PLAN UPDATES FOR POWER BOATS OVER 16'

Building notes typo: Jan. 2017

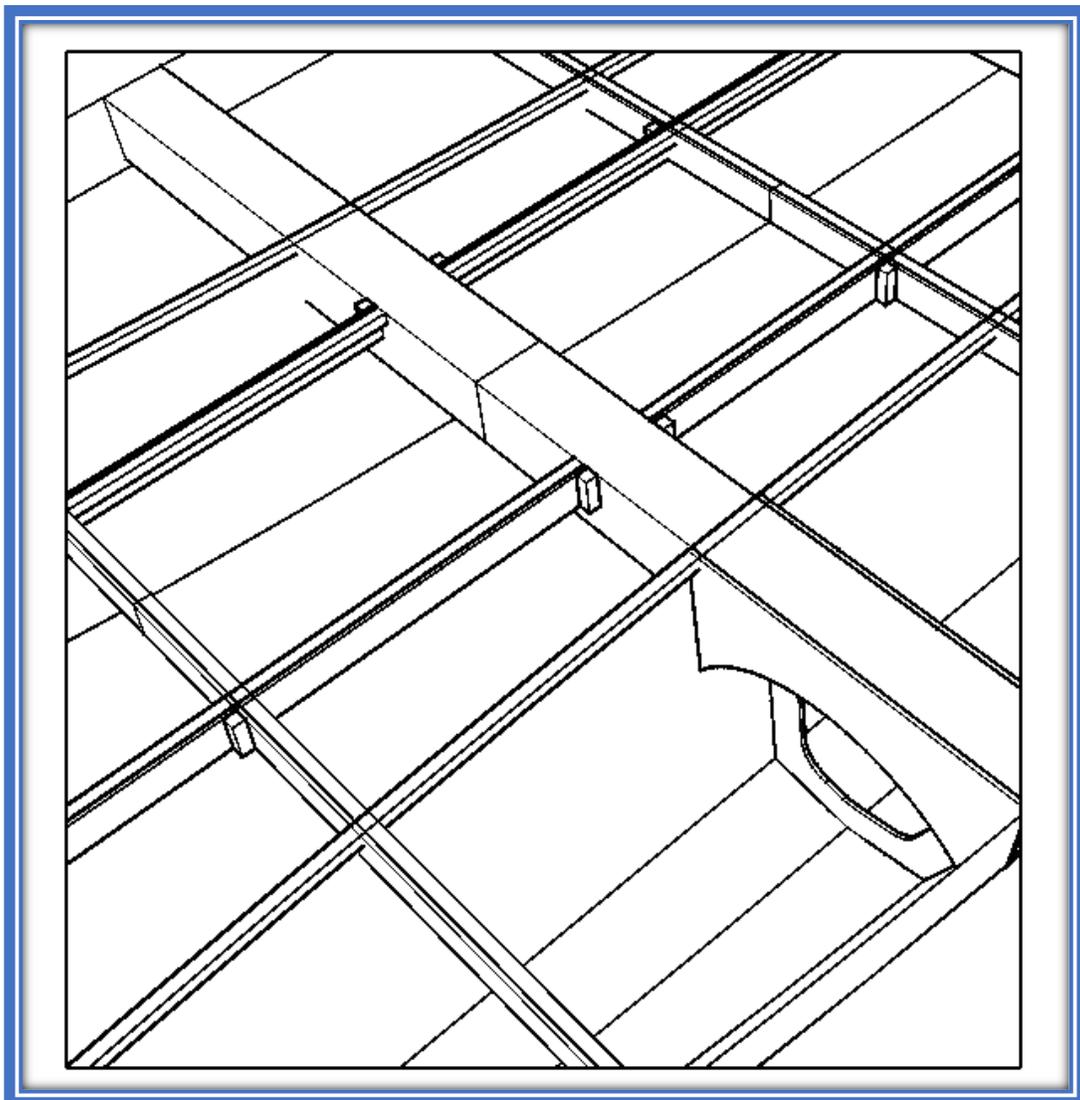
- ✍ Tape 6 oz. 12" wide should be 12 oz. 6".
- ✍ Stringers tabbing: 2 layers tape each side, not one.
- ✍ Added a new drawing titled "Fiberglass" to show lamination schedule.

MANGUSTA PLANS UPDATE

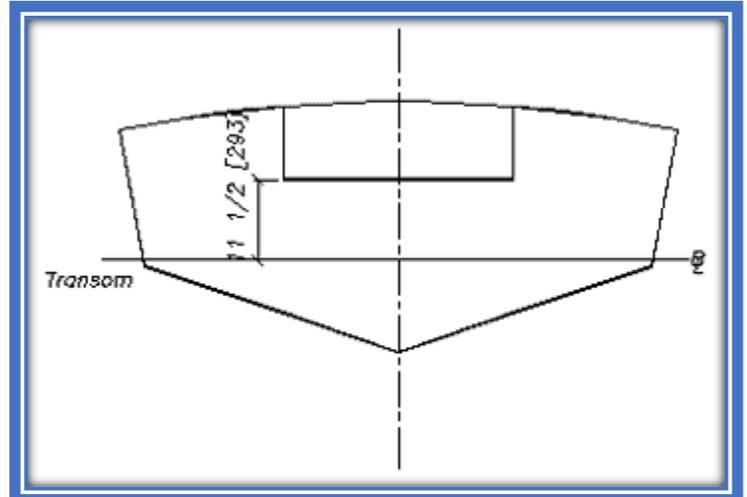
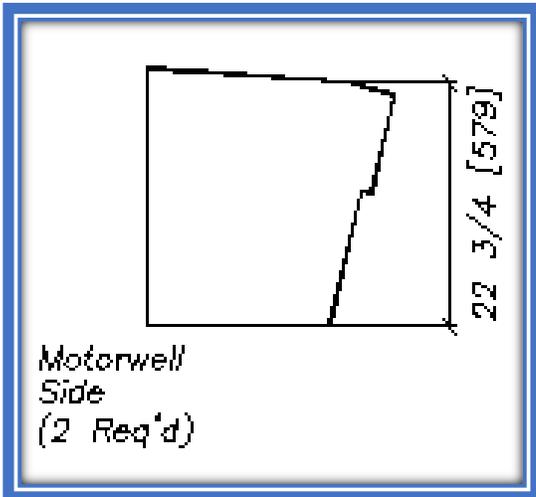
A motorwell side dimension was missing from the plans.

The transom dimension was correct but confusing.

SOLE

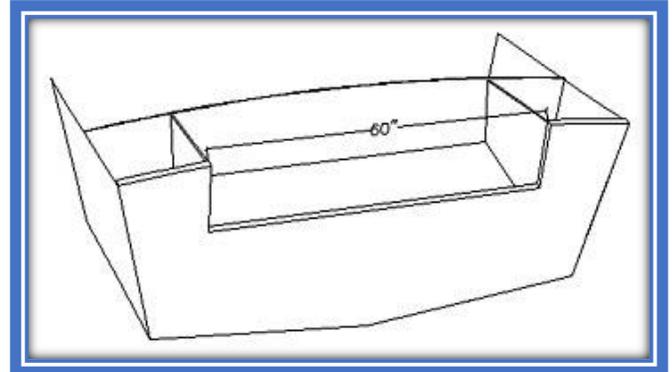
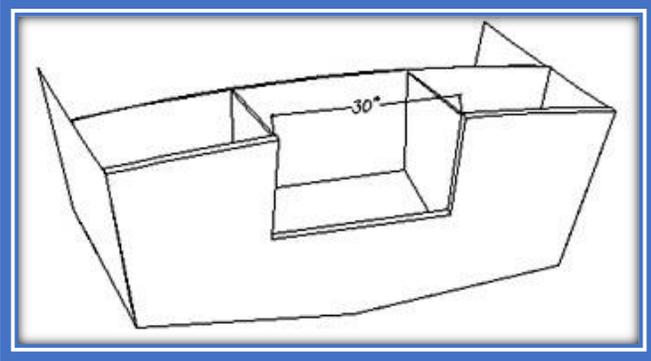
The XF20 is now available with an optional sole. This option requires 4 more sheets of plywood and some extra resin and fiberglass but results in a stronger hull. It also eliminates the risk of tripping over the stringers while fishing. The plans for the sole are included in the price of the plans. Those who purchased the plans can receive a free PDF update on request. Please email OrderDesk@e-boat.net.

GF18 PLANS UPDATE

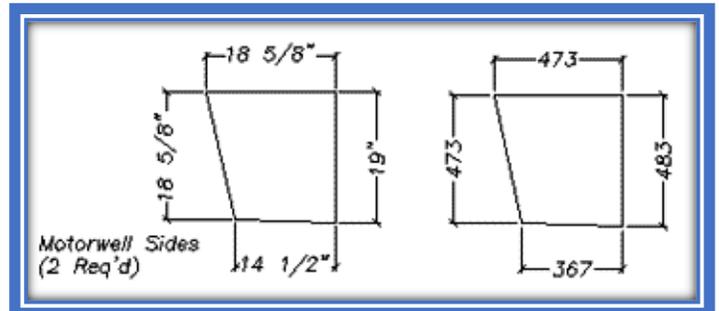
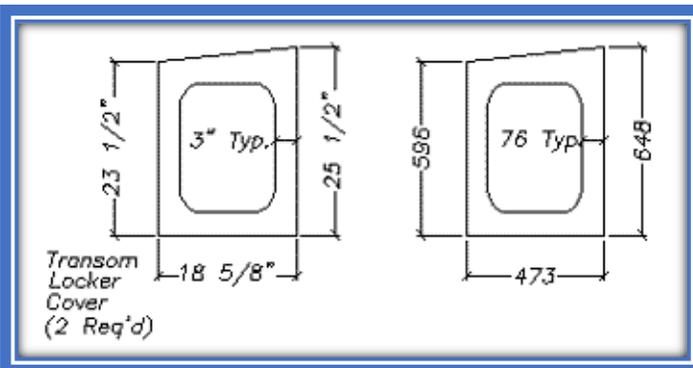
For all plans shipped before May 22nd, 2003 Check dimensions of Motorwell Sides and Transom Locker for the Center Console Version on all plans shipped between March 1st, 2003 and May 22nd, 2003.

DE23 CLOSED TRANSOM

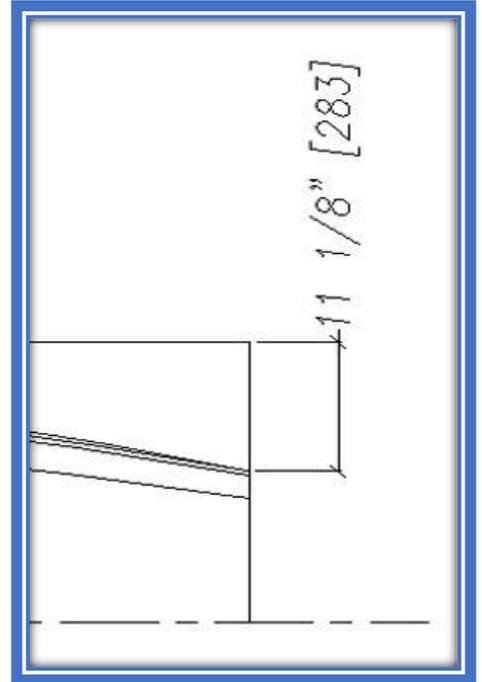
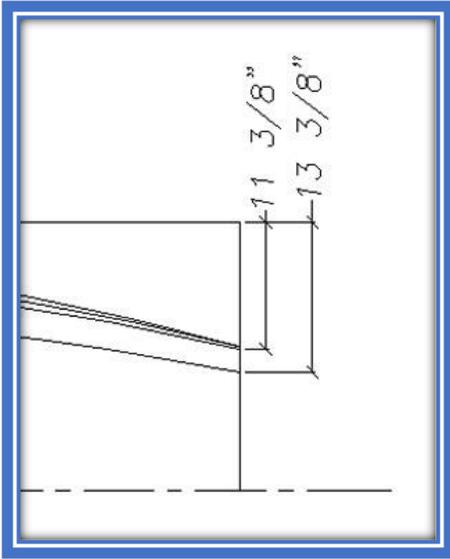
New version available: DE23 with a closed transom. For bracket installation. This new version is included in the plans starting August 10th, 2004. It frees a lot of room in the cockpit.

CS25 UPDATE

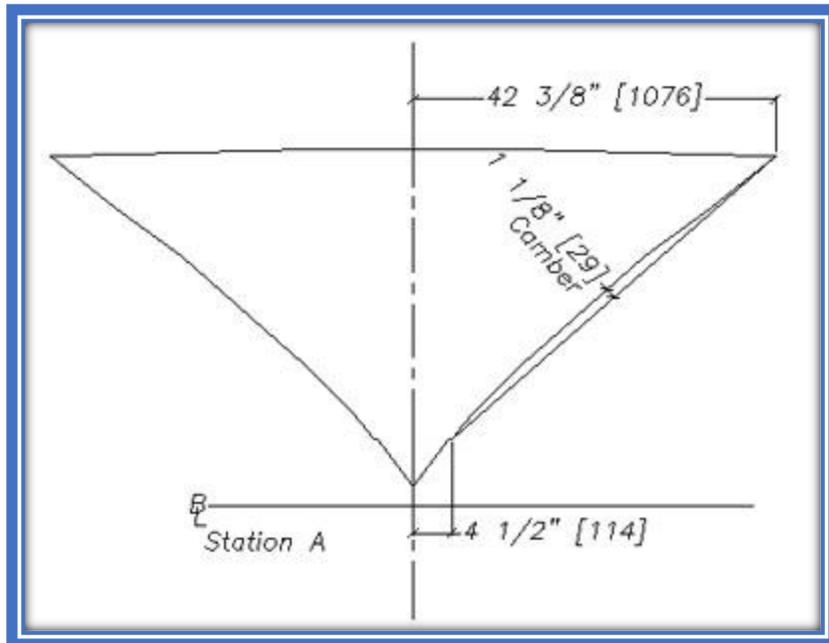
Dimension updates. There were a couple of dimensions missing from the chine panel on page E248/6.

On the second piece of the chine panel:

On the third piece of the chine panel:

B267/7 Details

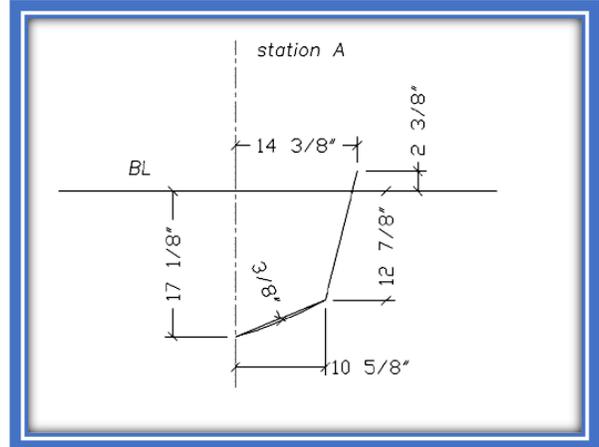
Suggested spray rail 1" wide.

SOLE

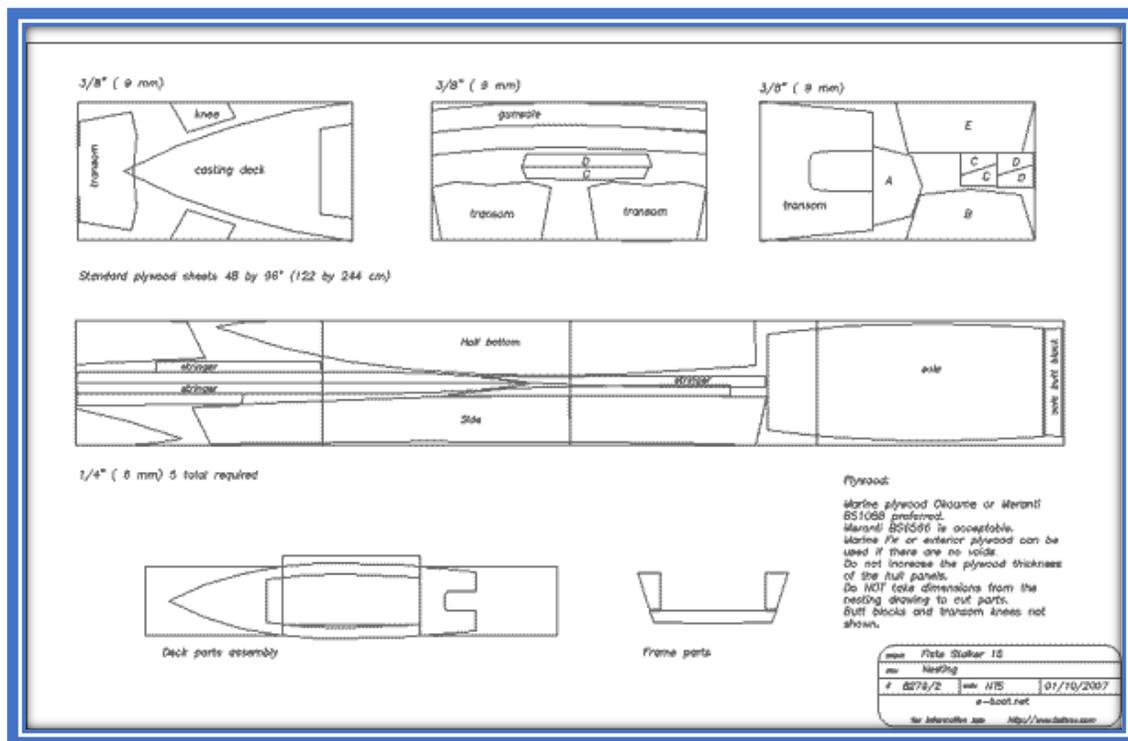
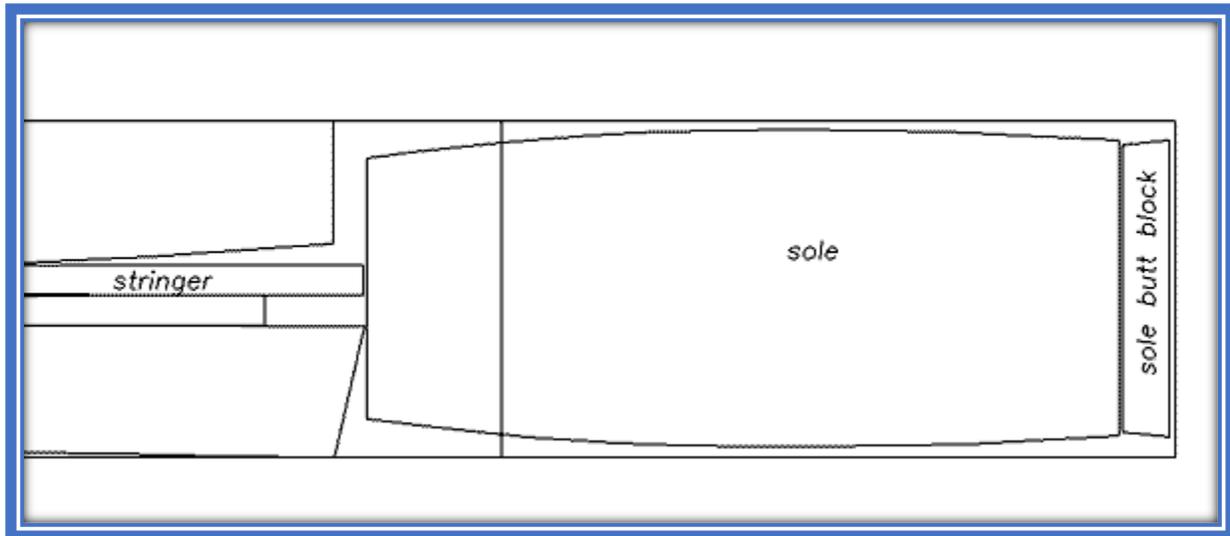
The first sets of plans did not show the sole in the nesting drawing. The sole got lost! It was missing from the nesting and the plywood BOM. The new BOM requires one more sheet of 1/4" plywood. Here is a picture of nesting drawing with the extra plywood sheet:

We added some text to the building notes, page 10:

- ✎ Cut the sole parts and check if they fit. Some minor adjustments may be required. The dimensions for the sole are simple: the length is the distance between the frames on which the sole sits, the widths are the widths of the frames spaced like the frames. This gives 4 points and that is sufficient to draw a curve that will fit the sides. Check against the hull before cutting: some minor differences may appear at this stage.

- ✎ The sole is made from two pieces of 1/4" plywood joined by a 6" wide butt block. The butt block fits between two frames but must be notched to avoid interference with the stringers. The builder can also use butt blocks in 3 pieces that fit between the stringers.

- ✎ We show a 1/4" sole which is sufficient if you fill space under the sole with foam. If you do not fill that space with foam, either use 3/8" plywood for the sole or cover the sole on each side with a layer of fiberglass fabric. If you choose to use 3/8", it will require 1.5 more sheets of 3/8" plywood. If you fiberglass the sole, you will need 7 more yards of wide fabric: total 20 yards. Foam is the best choice.

LB26 STATION NAMES

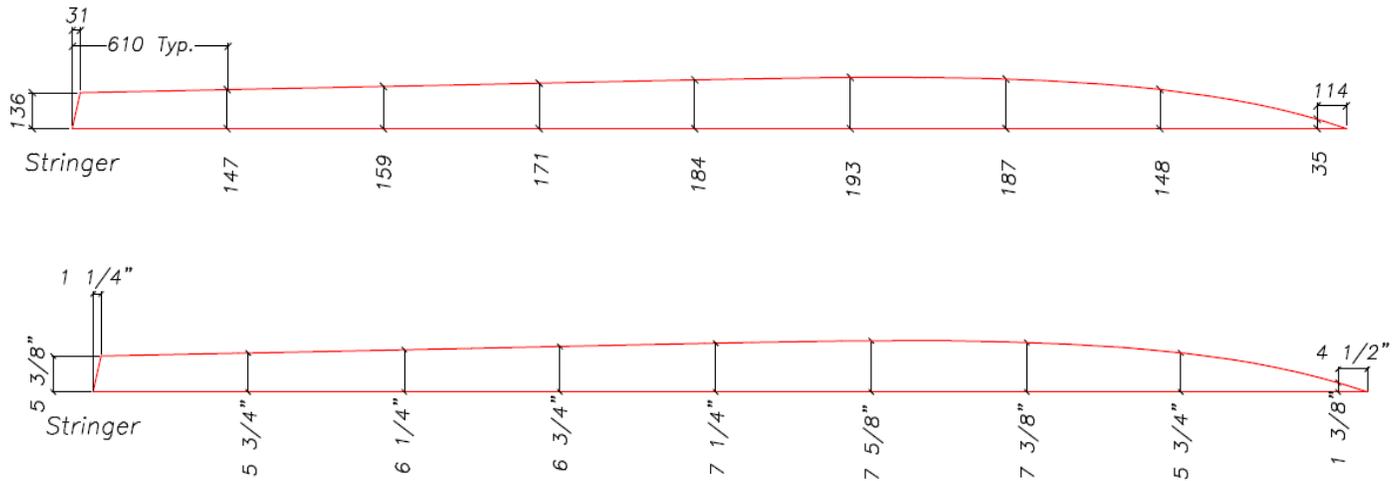
There is a discrepancy between the station names on the large blueprints and the small offset drawings.

The stations numbers on the large drawings (lines, construction etc.) correspond to the ones marked + on the small drawings with dimensions. For example, the station marked 0 on the large drawing is named 0+ in the small drawing. This is unimportant while building the jig but can be confusing if the builder uses the station names to locate the bulkheads.
